Access Compliance Report

Public Rights-of-Way

Intersection ID: 14302	Main Street: FARM_POND_LN	Cross Street: LAWRENCE_ORR_RD	Location: NE
ADA ID: 9EEAF6757B39	Ramp Type: Perp	Initial Pass/Fail: Fail	Overall Compliance: No
		Severity Score: 1.25

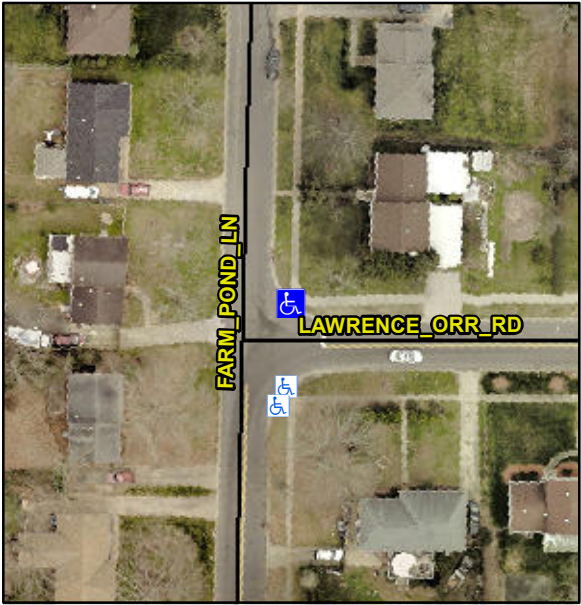
Codes/Mitigation Info/Possible Solution			Field Measurements/Component Compliance		
	Possible Solutions:		Compliance	Description	Data
	Remove & Replace Entire Ramp.		Yes	Ramp Length (in)	24.0
			N/A	Ramp Width (in)	48.0
			N/A	Flare Type LT	N/A
			N/A	Flare Slope LT (%)	N/A
			N/A	Flare Traversable LT?	N/A
			N/A	Flare Type RT	N/A
			N/A	Flare Slope RT (%)	N/A
			N/A	Flare Traversable RT?	N/A
			N/A	DWS Provided?	N/A
			N/A	DWS Contrast?	N/A
			N/A	DWS Length (in)	N/A
			N/A	DWS Full Width?	N/A
			N/A	DWS Offset (in)	N/A
			N/A	Gutter Ponding?	N/A
			N/A	Gutter Lip Ht (in)	N/A
			No	Painted X Walk1?	N/A
			To S	X Walk 2 Direction	N/A
			N/A	X Walk 2 Width (in)	N/A
			N/A	X Walk 2 Slope (%)	N/A
			N/A	X Walk 2 X Slope (%)	N/A
			N/A	Ramp inside XWalk1?	N/A
			N/A	Ramp inside XWalk2?	N/A
			N/A	Clear Space?	N/A
			N/A	Clear Space to XWalk (in)	N/A
			N/A	Storm Grate/Utility Hazard?	N/A
			N/A	Storm Grate/Utility Type	N/A

N/A	Surface Condition? (G/P)	Good
Surveyor Notes:					
N/A					
PROW/ADA:					
Not Found, R304.5.3					
Total Cost:		\$ 1850.00
